SITE VISIT

The Rockwood 10 project is a new construction project located in NE Portland, Oregon. The requested site observations on June 11th, 2021 were related to the building enclosure components currently being installed. Areas of specific review included hollow metal doors, storefront, and integration of HVAC components. Observations were made of the condition of the roof on Building C.

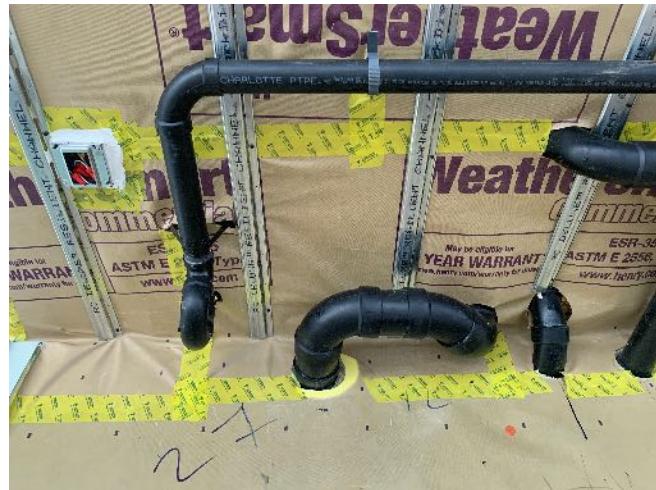
3 .01 Building B, 1st floor. Weeps have not been drilled in the sub sill of the storefront sill. Verify that weeps are installed per manufacturer's spacing recommendations.

Corrections made - complete.

SVR 03: 3.22

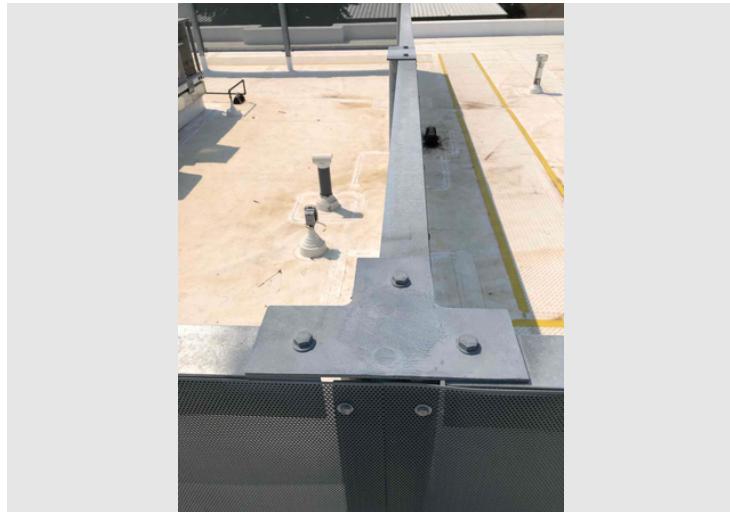
3 .22 Building C, Roof. These round pipes are the structural support for the mechanical screen. There are two holes in the plate on top of the pipe that provide a clear path for water into the roof assembly. These need to be plugged to prevent water ingress into the roof assembly. This needs to be remediated on all buildings in the project.

SVR 03: 3.08, 3.09

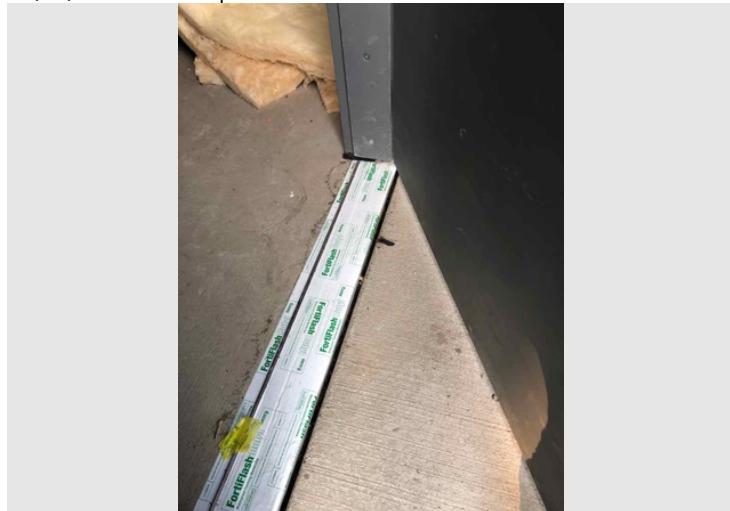
<p>3 .07 Building A, West soffit. WRB/AB component detailing is incomplete in some areas and exhibits damage in other areas throughout both soffits. Complete detailing where needed and repair or replace damaged WRB/AB components.</p>	<p>3 .08 Building A, west elevation. The hollow metal door sills have not been detailed as indicated in the drawings. For these doors under significant protective cover (low exposure), a face sealed approach can be used. Source a larger threshold, and seal it to the HM door frame and concrete while also sealing the HM door frame jamb to concrete and cladding using a backer rod and sealant.</p>
--	---

3 .09 Building A, South elevation. Hollow metal doors at exposed locations that have not been correctly detailed at the sill must be removed to allow for correct application of the sill detail.

<p>Corrections 90% complete. Doors removed and sills detailed in accordance with project documents.</p>
--	---

Corrections 90% complete. Doors removed and sills detailed in accordance with project documents.

SVR 03: 3.06

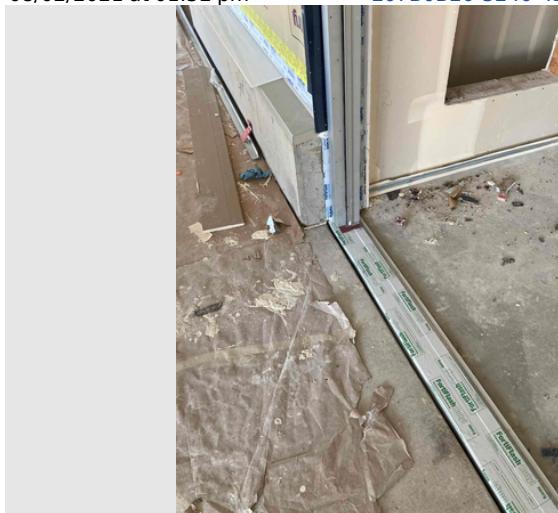
<p>3 .05 Building A, West elevation. This hose bib requires a solid block behind the hose bib to properly support the hose bib. The block doesn't need to be much larger than the face of the hose bib and should be protected by a head flashing, attached to the rainscreen, not back to the WRB.</p>	<p>3 .06 Building A, West elevation. Detailing of HVAC components is incomplete. See SVR 04 for more detail on this condition.</p> <p>Detailing completed and layouts revised due to structural framing changes.</p>
--	---

SVR 03: 3.11

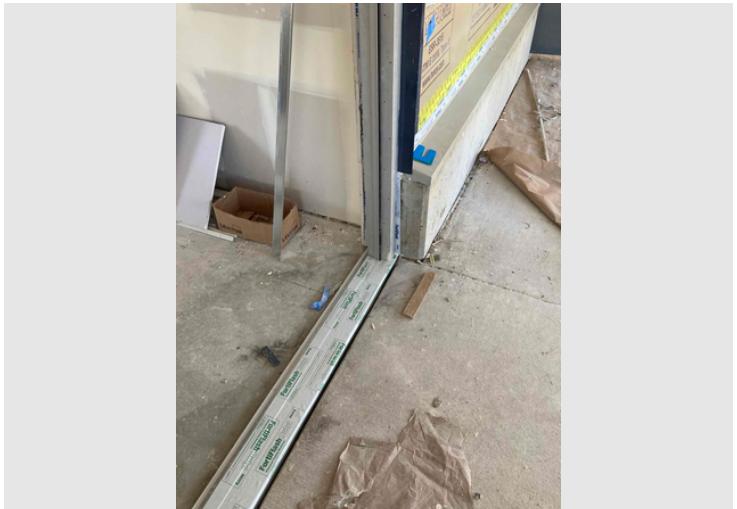
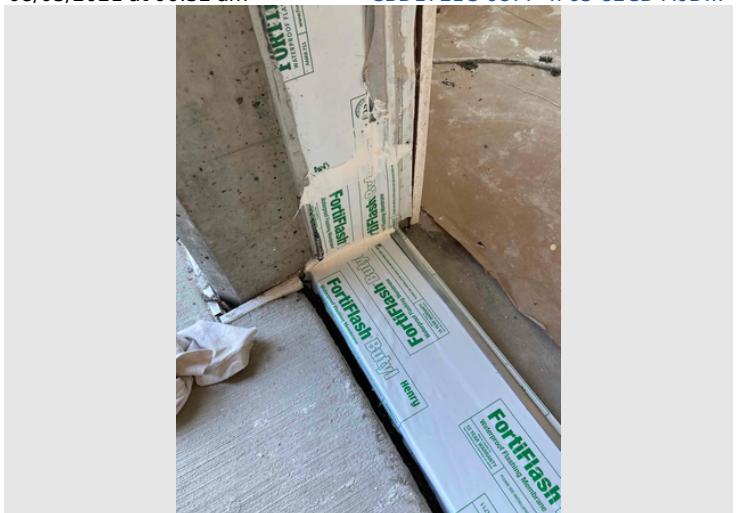
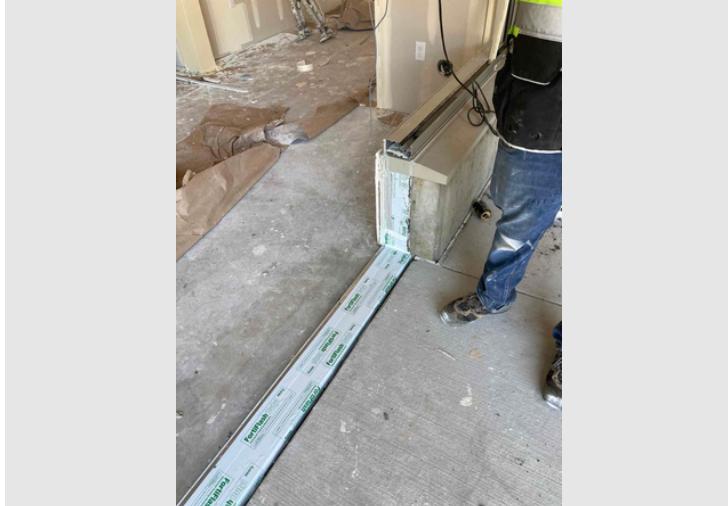
3 .11 Building A, North storefront entrance. The elevation of the storefront sill has been poured below the elevation of the adjacent exterior slab. The storefront framing will need to be removed to allow for a solid shim to be placed in the sill to provide a 1/4" drop from the sill to the adjacent exterior concrete. The solid shim will be stripped in with SAM per the original detail.

Corrections in progress at all WOM areas as discussed by LMC/QEC. HDPE being used for solid shim material as recommended by QEC.

SVR 03: 3.02, 3.03, 3.04, 3.07, 3.10

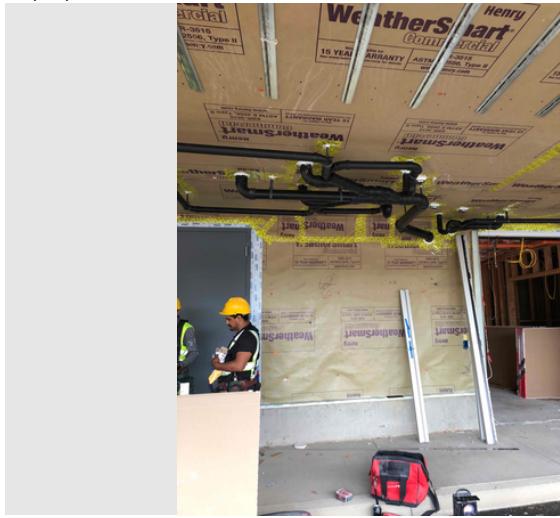
3 .02 Building A, West soffit. WRB/AB component detailing is incomplete in some areas and exhibits damage in other areas throughout both soffits. Complete detailing where needed and repair or replace damaged WRB/AB components.

3 .03 Building A, West soffit. WRB/AB component detailing is incomplete in some areas and exhibits damage in other areas throughout both soffits. Complete detailing where needed and repair or replace damaged WRB/AB components.

3 .04 Building A, West soffit. WRB/AB component detailing is incomplete in areas throughout both soffits. Complete detailing where needed prior to installing gypsum soffits.

3 .10 Building A, South soffit. WRB/AB component detailing is incomplete in some areas and exhibits damage in other areas throughout both soffits. Complete detailing where needed and repair or replace damaged WRB/AB components. This condition was evident while the drywall subcontractor was installing the gypsum soffit at this area. Verify that all WRB/AB detailing is complete prior to cover.

Detailing occurring in sequence and being inspected prior to siding installation at each elevation.

Detailing occurring in sequence and being inspected prior to siding installation at each elevation.

Detailing occurring in sequence and being inspected prior to siding installation at each elevation.
